**VIRTUAL MEETING OF THE BIRMINGHAM PLANNING BOARD**  
**WEDNESDAY, JULY 8, 2020**  
**7:30 PM**

**DATE:** July 8<sup>th</sup>, 2020  
**TO:** Planning Board  
**FROM:** Nicholas Dupuis, City Planner  
**SUBJECT:** 545 W. Brown – Design Review

**SUBJECT:** 34745 Woodward – Jax Kar Wash – Final Site Plan & Design Review (All changes since October 23, 2019 in blue type)

**SECOND FLOOR PLAN  
AND  
EXTERIOR ELEVATIONS**

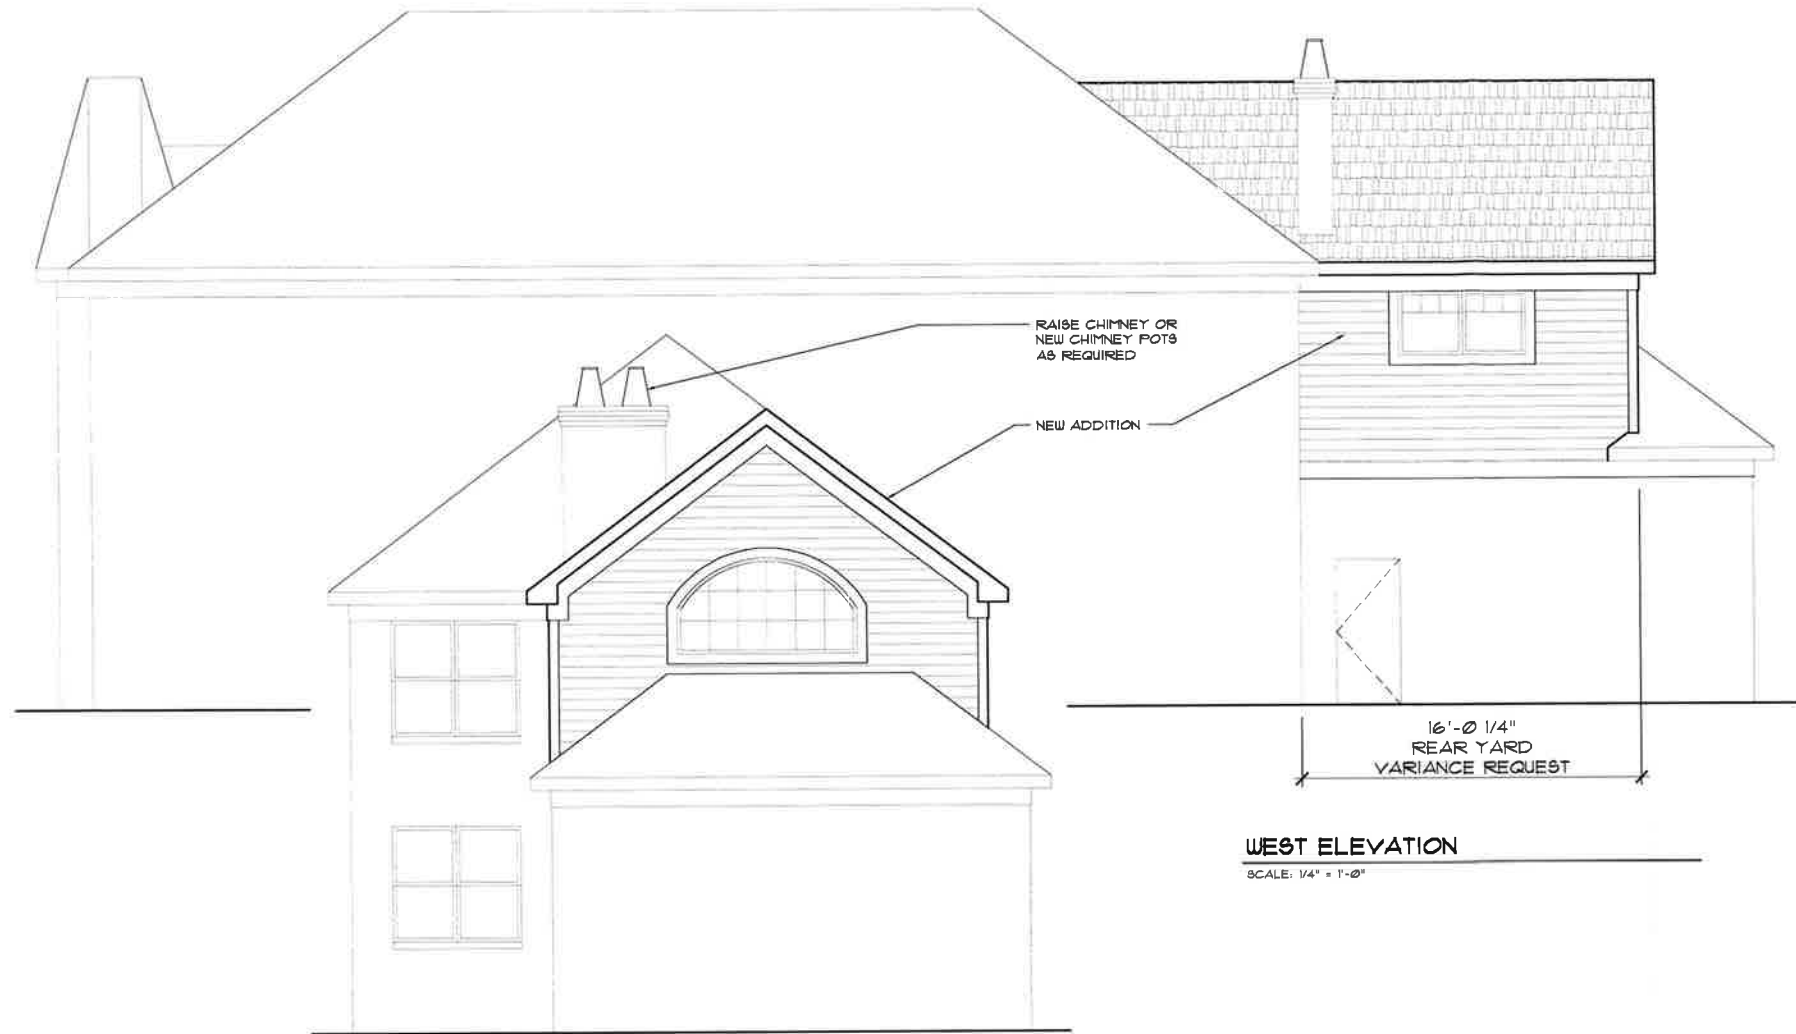
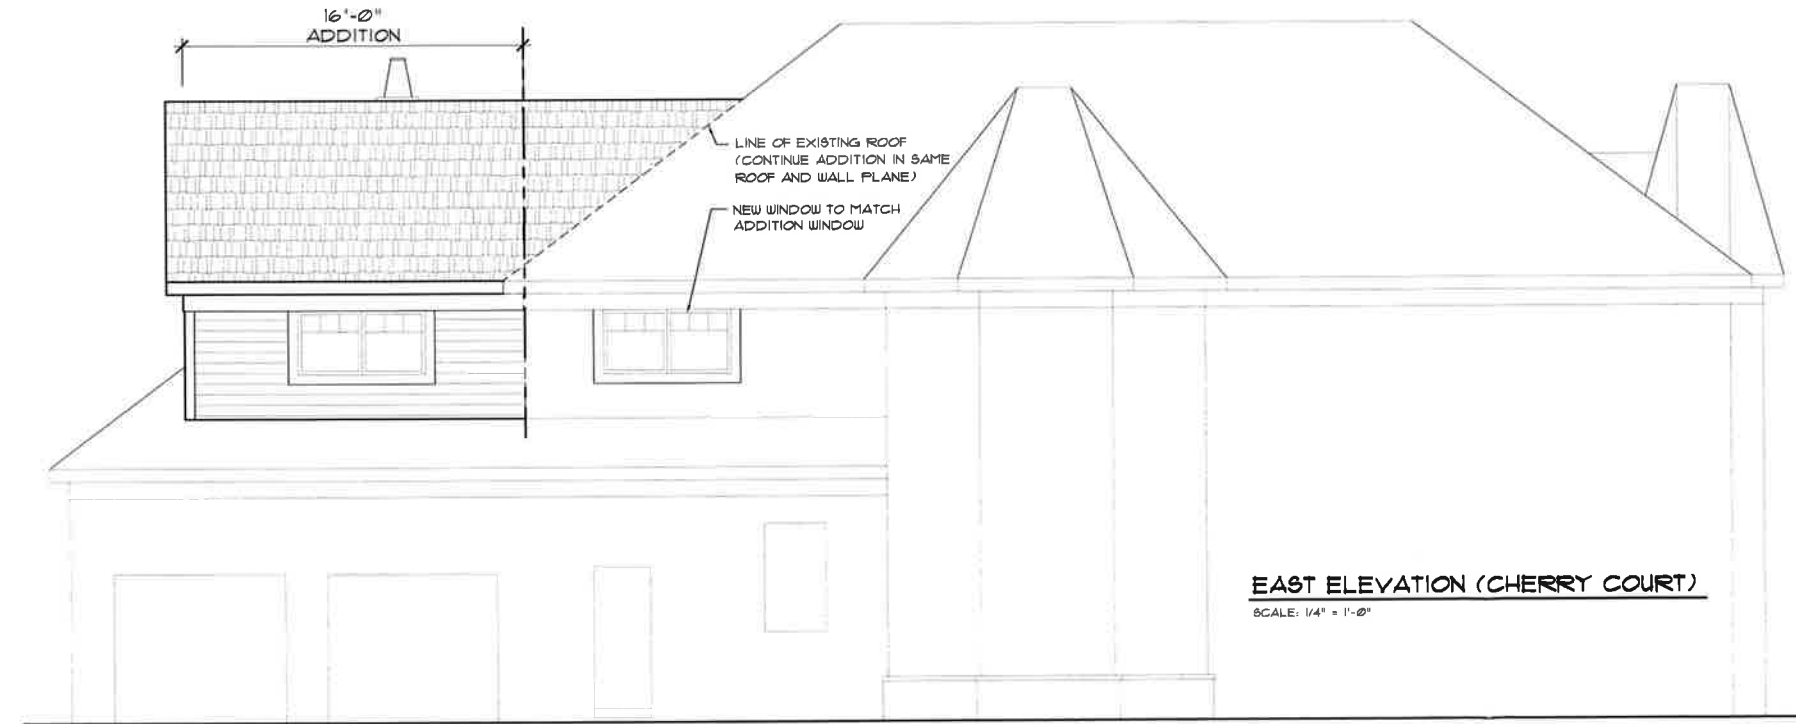
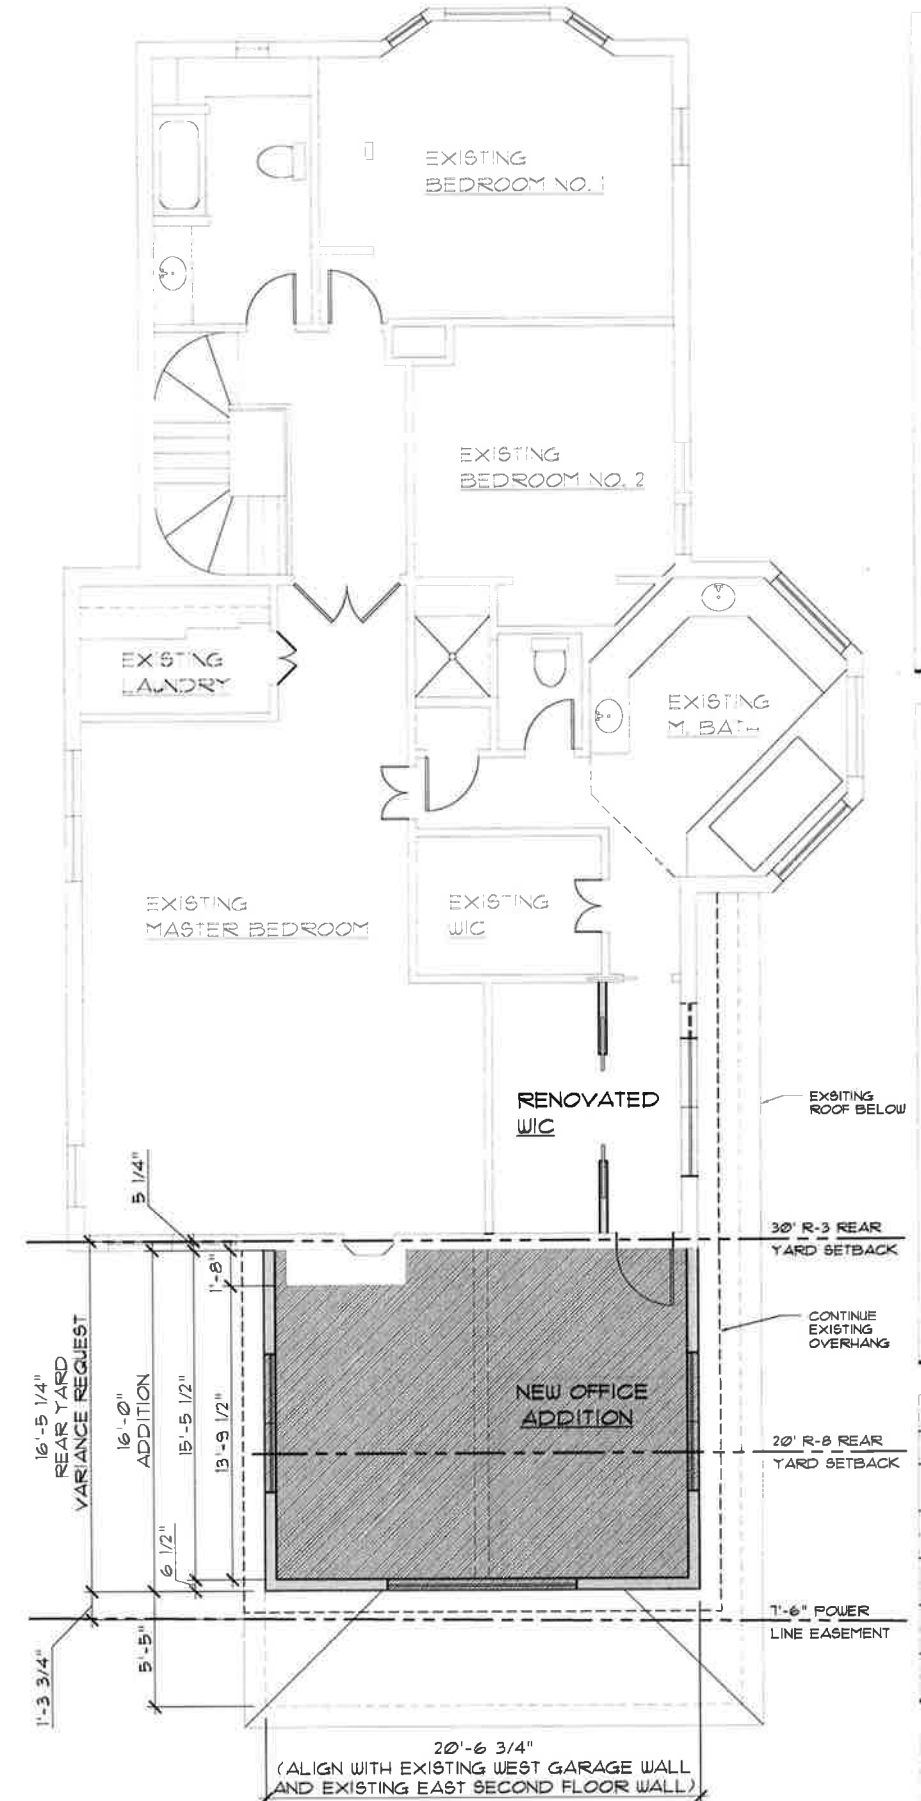
As described above, the applicant is proposing a modest addition to the existing building. The addition will contain a pitched roof with Timberline Ultra HD Shingles to match the existing roofing (Brown). The project will also involve the installation of 4 new Pella Lifestyle Series wood awning windows. 3 of the windows will be on the new addition, and 1 window will be added to the master bedroom to match the addition. Finally, the addition is proposed to be clad in eastern white cedar shingles, which are also proposed to match the existing second-story façade.

PROPOSED ARCHITECTURAL SITE PLAN  
SCALE: 1"=20'-0"  
AS101

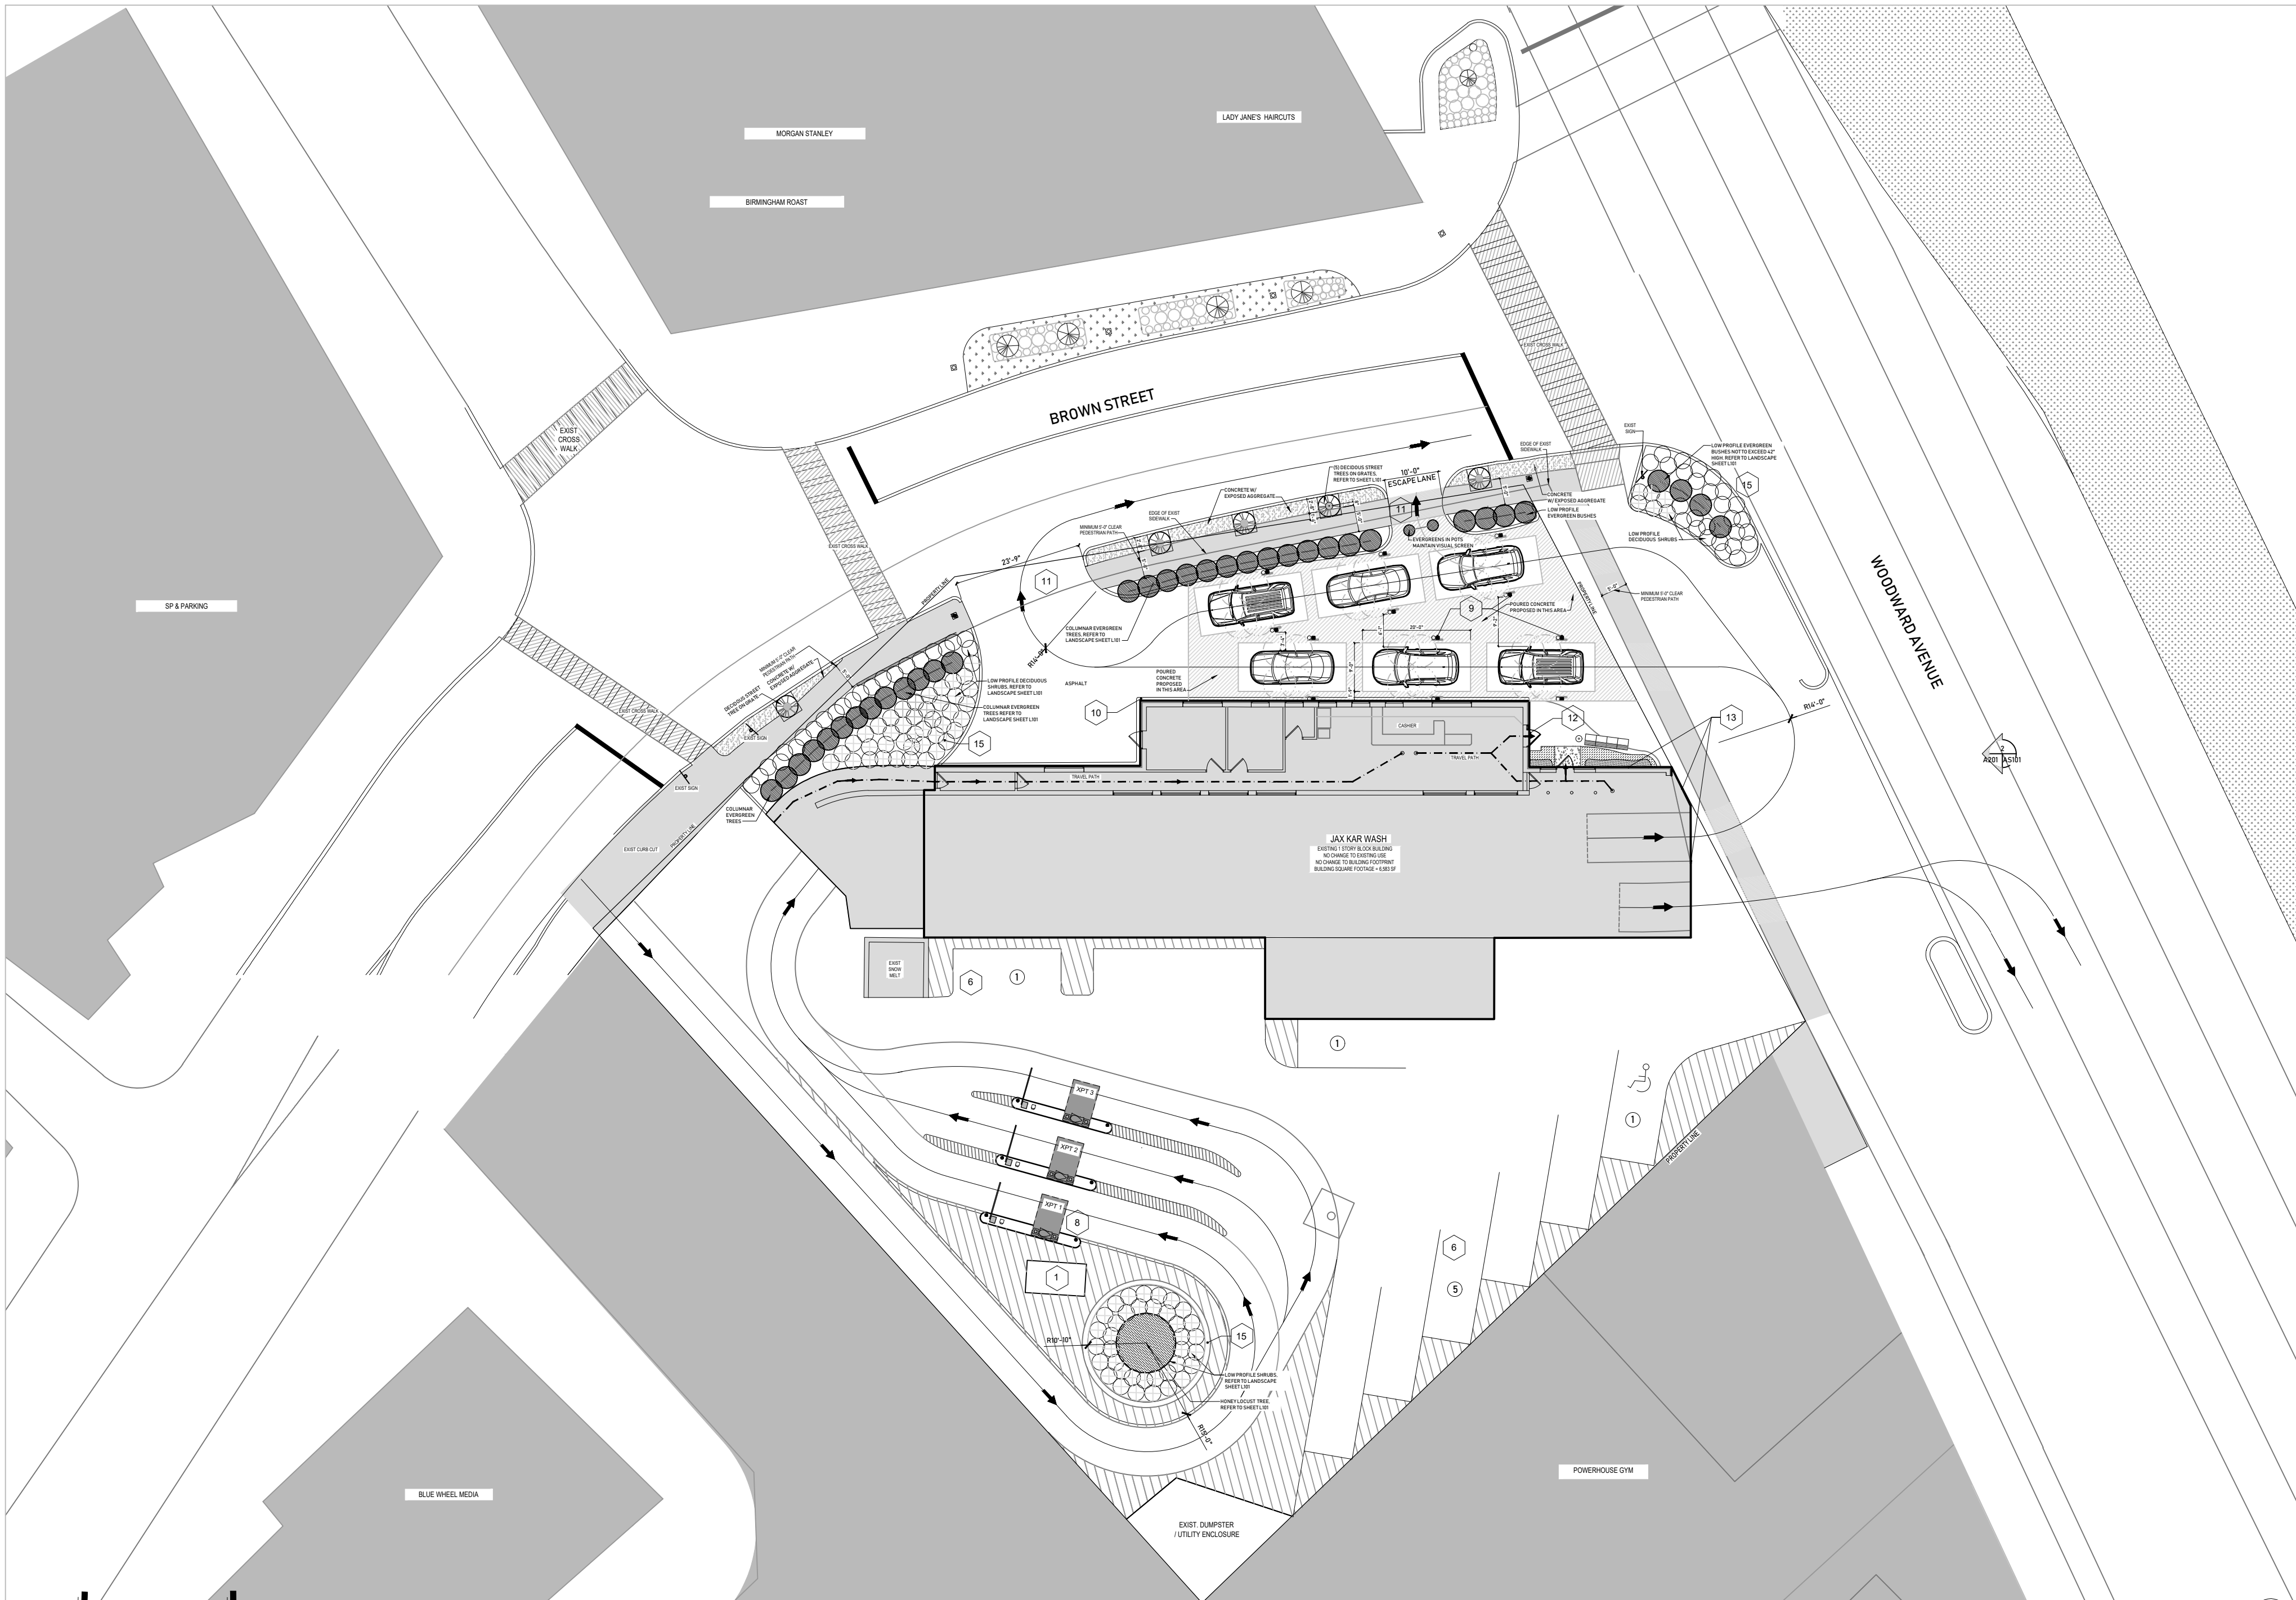
- 3.2 Parking Lot Screening – Article 4, Section 4.54(C)(3)(d) of the Zoning Ordinance requires that a masonry screenwall be placed along the front or side of any parking facility that abuts a street. The applicant has not proposed to screen the updated lot. The applicant has submitted revised plans that propose the addition of landscaped areas both at the northwest and northeast corners of the property to assist in screening the parking area on the north side of the building where 6 cleaning and detailing spaces are proposed. **Between these landscaped areas there is no screening proposed along the north property line to screen the vehicles parked for cleaning. No screening has been added on Woodward at the southeast corner of the site to screen the parking along the southern property line from Woodward. The applicant must screen the parking lot in accordance with Section 4.54 of the Zoning Ordinance, or obtain a variance from the Board of Zoning Appeals. The applicant has now revised the plans to include landscape screening along the south side of Brown Street with 17 Juniper shrubs proposed at a height of 6' to assist in screening the proposed vehicle vacuuming and detailing area north of the existing building. The previously proposed landscaped island at the corner of Woodward and Brown has been increased in size since October 2019. However, the island does not screen the detailing area along Woodward in its entirety, nor does it provide any screening for the parking area along Woodward near the southeast corner of the site. The applicant will be required to provide all required screening or obtain a variance from the Board of Zoning Appeals.**

**landscaped island at the corner of Woodward and Brown has been increased in size since October 2019. However, the island does not screen the detailing area along Woodward in its entirety. The applicant will be required to provide all required screening or obtain a variance from the Board of Zoning Appeals.**

- 3.4 Landscaping – Article 4, Section 4.20(C)(1) of the Zoning Ordinance exempts any property in the Downtown Overlay District from the standards outlined in Section 4.20(F) – Parking Lot Landscaping. However, the applicant has shown a circular landscape area on the proposed site plans. Although no landscaping is required, the applicant has submitted a landscape plan showing a central Honeylocust tree surrounded by gro-lo fragrant Sumac and Liriope plantings in the proposed raised circular landscaping bed.

Article 4, Section 4.20(G) requires at least one street tree for each 40 ft. of linear frontage. The applicant has roughly 185 linear feet of frontage along Brown Street, and roughly 105 linear feet of frontage along Woodward Avenue. Thus, the applicant is required to provide 5 street trees along Brown and 3 street trees along Woodward for a total of 8 street trees. The applicant has proposed 5 street trees on Brown, and no street trees on Woodward. **The applicant must submit plans showing 5 street trees on Brown and 3 street trees on Woodward for a total of 8 street trees, obtain a variance from the Board of Zoning Appeals, or obtain a waiver from the Staff Arborist. The applicant has now provided a landscape plan that shows 5 Ginkgo street trees are proposed along Brown Street.**

- 4.0 Streetscape Elements – As described above, the applicant is proposing to plant 5 street trees along Brown. There are no other streetscape improvements proposed. **The applicant has now revised the site plan to include a partially obstructed 5' sidewalk (utilizing ADA compliant tree grates as a portion of this width) along the south side of Brown Street as requested by the Planning Board. However, existing lighting poles provide obstructions within the 5' walking path. The Planning Board may wish to require the applicant to install pedestrian scale street lighting, benches, waste receptacles, or bike racks. The revised plans show the existing 2 cobra head fixtures which obstruct the walking path, and do not include any pedestrian scale street lighting, benches, waste receptacles or bike racks.**

1. **The plan has proposed three evergreen trees as well as other landscaping in the right-of-way of Woodward Ave., just south of Brown St. The proposal would result in an unacceptable sight distance hazard for the multiple vehicles that need to exit the JAX car wash facility on a daily basis. The City's code reads that no landscaping obstructions are allowed on private property within a 25 ft. sight triangle extending from a corner when a property is located adjacent to the intersection of two public streets. Evergreen trees are never allowed in the right-of-way for this same reason, as they would serve to obstruct the view of drivers attempting to pull on to the public street. We are also confident that the proposal will not receive approval from the Michigan Dept. of Transportation, due to the same sight distance concerns.**

2. **The plan has proposed the installation of five new trees in the narrow Brown St. right-of-way in front of the site. There have never been City trees in this area, due to the lack of public right-of-way. The proposal as shown is physically impossible to construct, and will not receive a permit from the Engineering Dept. as shown. Note that when the City's standard tree grates are installed, an additional six inches minimum of concrete must be installed between the street curb and the tree grate to provide concrete in which steel anchors that support the tree grate can be poured. Therefore, the center of the new tree would be 2.5 ft. south of the back of the curb, and it is surrounded by a 12 inch open circle for future tree growth. Even if the design uses the metal tree grate as a part of the walking surface, the City sidewalk would be only 4.7 ft. wide, in violation of City policy.**

3. While not in conflict with City code, the Engineering Dept. also does not recommend the installation of evergreen trees on private property to the west of the new Brown St. exit driveway. Assuming the driveway will be used frequently during business hours, the trees will serve as a sight distance conflict between the drivers using this exit, as the trees will obscure the view of both pedestrians and bicyclists that may be using the adjacent City sidewalk. Lower growing plants would be more appropriate.
